December Minutes

<u>Thursday, December 1, 2016; 6:30 p.m.</u>

The eleventh meeting for the year 2016 of the Historic Preservation Commission was held on Thursday, October 20, 2016 in the Columbia/Ellicott City Room located 3430 Court House Drive, Ellicott City, MD 21043.

Figure 10 - Front door

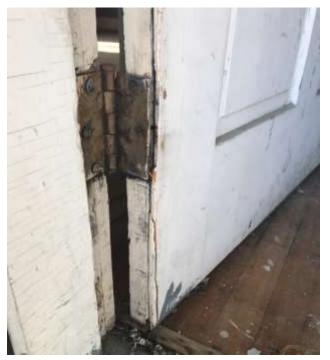
Front doors - The front door does not appear to be damaged beyond repair. It is located under a porch and was covered with a storm door so it should not be in so poor of a condition that repair would not be possible. Staff requested additional photographs showing damage and the Applicant has submitted the photos shown in Figures 10-12 below. Staff recommends denial of replacement front door and recommends the door be repaired and tax credit pre-approval for the work.

- 1) Denial of replacement of the front door and recommends the door be repaired and tax credit pre-approval for the work.
- 2) Approval of the replacement of the side basement door and tax credit pre-approval for the work.
